# UNITED STATES PATENT AND TRADEMARK OFFICE

10/825,769

<b>Office Action Summary</b>	<b>Application No.</b> 10/825,769	<b>Applicant(s)</b> ANTHONY ET AL.	
	<b>Examiner</b> VICTOR MACARTHUR	<b>Art Unit</b> 3679

**DETAILED ACTION*****Drawings***

**FIG. 38**

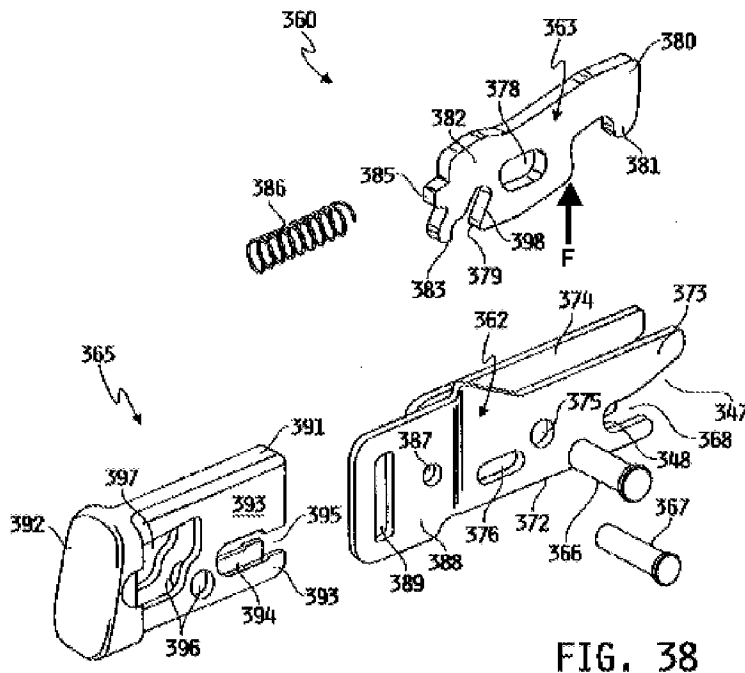
Claims 41, 42 and 44-58 are rejected under 35 U.S.C. 102(b) as being anticipated by Anthony (US 2003/0030310) (see marked-up figure below).

Claim 41. Anthony discloses (fig.38) a coupling device, the coupling device comprising:  
a frame (362 and 365) defining a void (void in 362 receiving left portion of 363) therein and a first opening (bottom opening in 362) to the void, and further defining a mouth (368) that is separate from the void, the mouth defining an opening (right opening of 368) thereto, a lever (363) movably mounted to the frame at a mounting location (378), the lever having a distal end

(right portion of 363) that is movable relative to the frame between a first position (similar to fig.44) in which the distal end of the lever covers the opening of the mouth and a second position (similar to fig.35) in which the distal end of the lever does not cover the opening of the mouth, the lever defining a manipulation portion (bottom portion of 363 between 378 and 380) between the mounting location and the distal end, the manipulation portion responsive to a direct pushing force (F) applied thereto to extend through the first opening and into the void when the lever moves from the first position to the second position, and a biasing member (386) positioned between the lever and the frame, the biasing member biasing the lever toward the closed position. Furthermore:

Claim 42. Anthony discloses the coupling device of claim 41 wherein the frame further defines a second opening (upper opening in 362) separate from the mouth (in that the mouth is below the upper opening in 362), and wherein the distal end of the lever extends out of the second opening (similar to fig.39) when the lever is moved from the first position to the second position.

Claim 44. Anthony discloses the coupling device of claim 41 further comprising a cover (361) configured to receive the frame and lever therein, the cover defining a mouth (371) that aligns with the mouth defined by the frame when the frame is received within the cover.

Claim 45. Anthony discloses the coupling device of claim 44 wherein the cover defines an opening (369) through which the manipulation portion of the lever is accessible (via 371 with any long narrow tool such as a screw driver, punch, etc.)

Claim 51. Anthony discloses the coupling device of claim 41 further comprising means (354) for protecting the lever from dust and chipping.

Claim 52. Anthony discloses the coupling device of claim 41 further comprising means (365) for allowing a user to simultaneously maintain a grip on the coupling device while moving the lever to the open position.

Claim 53. Anthony discloses the coupling device of claim 41 further comprising means (354) for distinguishing by either or both of feel and sight the coupling device from another device.

Claim 54. Anthony discloses the coupling device of claim 41 wherein the frame and the lever comprise a frame assembly, the frame assembly being formed of metal, and further comprising means (361, Kevlar, para.0069) for thermally insulating the metal of the frame assembly.

Claim 56. Anthony discloses (fig.38) a coupling device, the coupling device comprising: a frame (362) defining a mouth (368), the mouth defining an opening thereto, a lever (363) movably mounted relative to the frame and having a first position in which the distal end of the lever covers the opening of the mouth and a second position in which the distal end of the lever does not cover the opening of the mouth, the lever having a manipulation portion (bottom portion of 363) responsive to a pushing force applied directly to the manipulation portion to move the lever between the first position and the second position, a biasing member biasing the lever toward the first position, and a cover (361) configured to receive the frame, lever and biasing member therein, the cover defining a mouth (371) that aligns with the mouth defined by the frame when the frame is received within the cover, the cover further defining a plurality of surfaces that are configured to resemble (in as much as applicant's own invention does) at least a nose, eyes and ears on a head of a dog. Furthermore:

Regarding the prior art rejections, the applicant argues that Anthony does not disclose "a frame defining a void therein and a first opening to the void" as required by claim 41. This is not persuasive. Anthony discloses a frame (362 and 365) defining a void (void in 362 receiving left portion of 363) therein and a first opening (bottom opening in 362) to the void.

- Anthony discloses a lever (363) defining a manipulation portion (bottom portion of 363 between 378 and 380, actable upon by force F) between the mounting location (378) and the distal end (right portion of 363), the manipulation portion responsive to a direct pushing force (F) applied thereto to extend through the first opening (bottom opening in 362) and into the void when the lever moves from the first position to the second position.
- The fact that the Anthony lever can be manipulated via depression of (365) does not detract from its capability of being manipulated by application of force (F) as shown in the marked-up figure above.
